General Technology Corporation

FAX Transmission

NONCONFORMANCE MATERIAL/RMA REPORT

NCMR NUMBER	2037	CUSTOMER RETURN
DATE	10/11/2004	RMA NUMBER
CUSTOMER	SLAC	QUANTITY RETURNED
CUSTOMER	PAT LUJAN	VENDOR DEFECT
VENDOR	General Technology	QUANTITY REJECTED
PART NUMBER	LAT-DS-01646	3
LOT QUANTITY	3	PRODUCTION
SALES ORDER	F17200	QUANTITY REJECTED
PURCHASE ORDER	48799	REWORK
LOT NUMBER		QUANTITY
WORK ORDER	110154,110155,110156	PURCHASING DEFECT
INITIATOR	P. LUJAN	PURCHASING QUANTITY REJECTED
ASSIGNED TO	PAT LUJAN	3
DATE REQUIRED	10/11/2004	
ASSIGNED TO		
DISCREPANCY	SN's "1, 2 and 3" (Currently not identified as with SLAC numbers)

SO NO: F17200	PART NO: LAT-DS-01646	REV: 54
ASSEMBLY NAME: CCA, TEM		QTY: 2

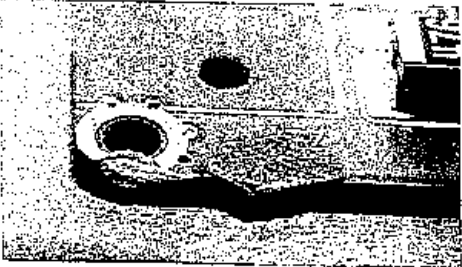
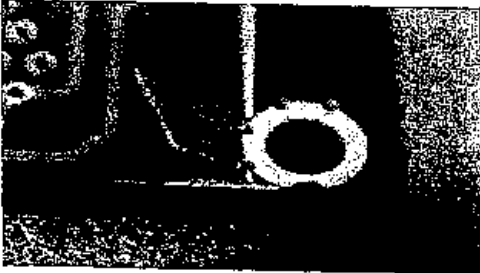
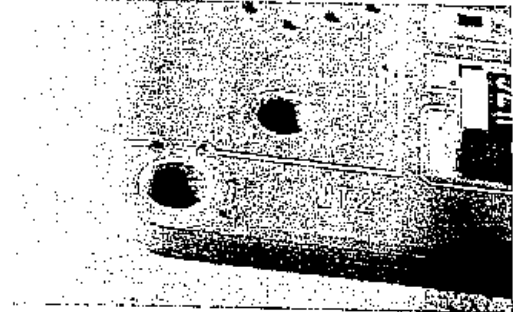
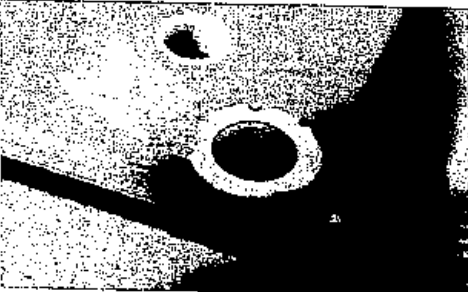
Finding: Customer finding - SN 1, 2 & 3
PWA dropped from an approximate distance of 36". PWB sustained damage (dings) along edges of board. Photographs were e-mailed to SLAC for evaluation.

STEP	OPERATION	Operator Sign Off.	Date	Time spent
	<p><i>THIS REWORK TRAVELER APPLIES COATING MATERIAL TO LOCATIONS ON CORNERS OF CCAS DAMAGED BY FALLING OFF A STORAGE TRAY. REWORK AUTHORIZED VIA EMAIL FROM B. ESTEY, DATED 12/12/04; 4:21 pm (ATTACHED)</i></p>			
REF	<p>PICTURES OF DAMAGE TO SN #2 (614)...</p> <div style="display: flex; flex-wrap: wrap;">   </div> <div style="display: flex; flex-wrap: wrap; margin-top: 10px;">  </div> <p>NOTE DEFORMED CORNER PADS.</p>			
REF cont.	<p>PICTURES OF DAMAGE TO SN #3 (612)...</p> <div style="display: flex; flex-wrap: wrap;">   </div> <div style="display: flex; flex-wrap: wrap; margin-top: 10px;">   </div> <p>NOTE DEFORMED CORNER PADS.</p>

Immediate Correction(s): Evaluate the condition of the board edges, re-inspect at 10X magnification 100% for any and all damage possibly caused to components themselves; no other damage found. Reference GTC rework traveler attached for PWB edge repair.

STEP	OPERATION	Operator Sign Off.	Date	Time spent
1	<p><i>THIS REWORK TRAVELER APPLIES COATING MATERIAL TO LOCATIONS ON CORNERS OF CCAS DAMAGED BY FALLING OFF A STORAGE TRAY. REWORK AUTHORIZED VIA EMAIL FROM B. ESTEY, DATED 12/12/04; 4:21 pm. (ATTACHED)</i></p> <p>Serial numbers: #2 (614), #3 (612) REFERENCE NCMR # 2082 AND # 2083.</p>			
2	<p>TOOLS AND MATERIALS:</p> <p>MIXING CONTAINER - PLASTIC, METAL, OR GLASS</p> <p>MIXING UTENSIL - PLASTIC, METAL, OR GLASS</p> <p>SCALE - GRAM, CALIBRATED</p> <p>PLIERS - METAL, NEEDLE, SMOOTH JAW SURFACE</p>			
3	<p>MIX A SMALL AMOUNT OF THE TWO PARTS OF COATING MATERIAL, ARATHANE 5750, FOR BRUSH APPLICATION TO DAMAGED LOCATIONS ON EACH CCA. REFER TO PICTURES ON FOLLOWING PAGE. USE THE FOLLOWING RATIO TO MIX THE MATERIAL:</p> <p>PART A 18 PARTS BY WEIGHT EXAMPLE: (0.54 GRAMS)</p> <p>PART B 100 PARTS BY WEIGHT (3.00 GRAMS)</p> <p>MIX SLOWLY, BY HAND, TO MINIMIZE AIR ENTRAPMENT.</p> <p>POT LIFE IS APPROXIMATELY TWO (2) HOURS).</p> <p>LET MIXED MATERIAL STAND FOR HALF AN HOUR TO RELEASE ANY ENTRAPPED AIR.</p> <p>RECORD MIXTURE AMOUNTS, MATERIAL LOT/BATCH CODE, AND EXPIRATION DATE, BELOW:</p> <p>AMOUNTS MIXED: PART A: _____ PART B: _____</p> <p>CODE: _____ EXPIRATION DATE: _____</p>

SO NO: F17300	PART NO: LAT-DS-02388	REV: 55
ASSEMBLY NAME: CCA, LAT TOWER POWER SUPPLY (TPS)		QTY: 3

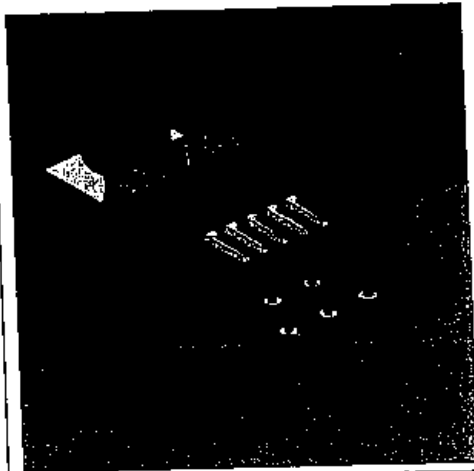
Pat,
Part affected is 02388 (typo on the NCMR).
See attached for lead trimming and hardware change details.
Dave T.

STEP	DESCRIPTION	Operator Sign Off.	Date	Time spent
	<p>APPROVED RESOLUTION FOR OPERATION NCMR 2089. 12/16/04</p> <p>This document outlines modification to components U6, U7, U8, U10, U15, U17, and U18 - MAXIM MAX724ECK, and subsequent installation to the CCA. The modification, prepared as applicable to comply with IPC-7721, Section 6.1, entails lead clipping, to remove non-applicable 'as supplied' lead orientation, 'hook-up' wire preparation, mechanical installation with smaller hardware (#4, vs. #6), device lead termination, PCB and lead termination, flux cleaning, inspection, subsequent bonding of the devices using RTV, and final inspection of the rework.</p>			
1	This Rework Traveler is applicable to unit Serial numbers: #1, #2, #3.			
2	<p>Clip leads of seven (7) MAX724ECK devices to obtain a 0.140" lead length, 5 places. Clamp each lead to be clipped using flat-faced needle nose electronics pliers.</p> <p>CONTACT SLAC QAR FOR WITNESS OF WORK.</p> <p style="text-align: center;">MINIMUM CUT AT 1ST BEND</p> <div style="display: flex; justify-content: space-around;">   </div>	GTC	GTC	GTC
